Project Name: 415 North Swinton Avenue, Del Ida Park Historic District
Project Location: 415 North Swinton Avenue, Del Ida Park Historic District
Request: Certification of Appropriateness (COA) for additions and alterations to a contributing structure

---STAFF REPORT---

ITEM: 415 North Swinton Avenue, Del-Ida Park Historic District (2016-191) – Consideration of additions and alterations to a contributing structure.

LEFT SIDE ELEVATION (NORTH)

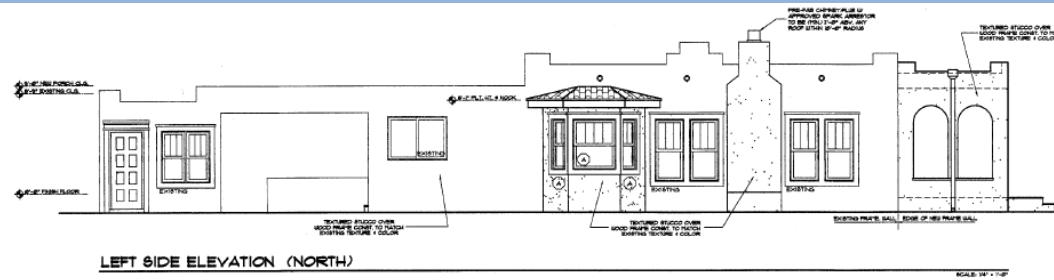
The subject proposal is similar to the previously approved COA with respect to the front porch addition and new fireplace and chimney. New to the proposal is a small bay window addition on the north elevation with a barrel tile roof. The windows are 2/1 on the smaller angled walls, and 4/1 on the central wall. The windows will be impact rated aluminum, and contain dimensional muntins. The noted stucco pattern is to match the existing historic structure.

In consideration of the Visual Compatibility Standards, the proposed additions are generally appropriate and compatible while adding additional interest with slight detailing to an otherwise very simplistic structure. However, as previously noted, the bay window should be revised to a side addition, with a slight revision to the angled wall planes. The front door specification needs to be provided which matches the elevation; the window specifications should also be provided to ensure appropriate windows with dimensional muntins and no mirrored or tinted glass finishes.

1. That true barrel tiles be utilized, as opposed to "S" tiles;
2. That the stucco pattern for the porch, chimney, and bay window differ from that of the existing stucco pattern;
3. That the bay window be revised to a squared off side addition;
4. That window specifications be submitted which illustrate dimensional muntins, and indicate that no mirrored or tinted glass will be utilized;
5. That the tile design around the entry be submitted; and,
6. That a specification for the new entry door be submitted.

FRONT ELEVATION (WEST)

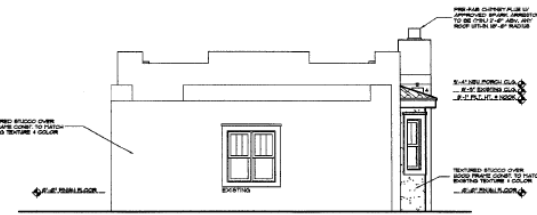
The Board comments were supportive, and they approved the request with the added condition that the light fixtures be added to the front, with specifications submitted to Staff.

The proposed front porch, which is inset 1'4" from each side of the front wall, measures 11' deep, and spans 21'9" across the front elevation. The porch height (12") is lower than the original building and the proposed parapet (9") mirrors that of the original building. Two arched opening are located on each side of the porch, and a set of two arched openings flank the entryway. All arched openings are located above a 3' high knee wall and measure approximately 6' in height. The arched entry contains an arched wood door with beveled panels and is accented by a decorative tiled border. Three steps provide access to the porch. The proposed chimney will be located on the side street (north) elevation, facing NE 5th Street, centered between two pairs of existing windows. Both the porch and chimney will be finished in stucco.
